European Union Agency for the Cooperation  
of Energy Regulators

# Analysis of the Consultation Document on the Gas Transmission Tariff Structure for Belgium

NRA: CREG  
TSO: FLUXYS BELGIUM

6 February 2023

Figure 1 Re-valued RAB as part of the total RAB for Belgium 2017 - 2022

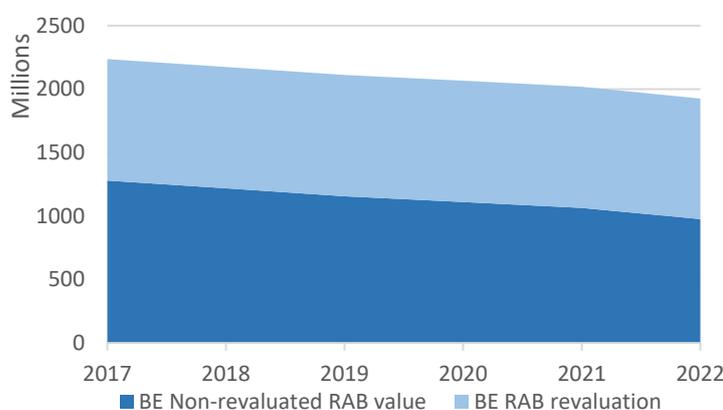
- (120) Based on this information, the Agency has only been able to build a minimum understanding of the role that the revaluation plays in the broader allowed revenue methodology. To the understanding of the Agency, the revaluation was approved as a modification of the opening value of the RAB in 2003. This opening value results in a revaluation that remains constant until 2050 at a level of EUR 950 million increasing the value of the RAB to EUR 2.079 million<sup>27</sup>. This is shown in Figure 1 below over the 2017-22 period. The revenue that the TSO is allowed to recover on the revaluation is calculated multiplying the costs of capital (calculated as the weighted average cost of capital – WACC-) times the value of the revaluation. On the basis of the 4.79% WACC approved for the 2024-27 period, this results in EUR 45 million per year, which over 4 years results in EUR 182 million. Fluxys nevertheless communicated to the Agency, that this value has to be further adjusted based on the applicable gearing ratio. Fluxys and CREG did not provide the exact amount that is allocated to tariffs on a yearly basis but estimated it at around EUR 25 million/year, which amounts to EUR 100m for the next four years.

- (121) The Agency emphasizes the importance of providing transparency on the allowed revenue methodologies, including on the parameters and the values. ACER proposed in its 2018 Allowed Revenue Report<sup>28</sup> a revision of the allowed revenue publication requirements with a view to providing greater clarity to stakeholders.
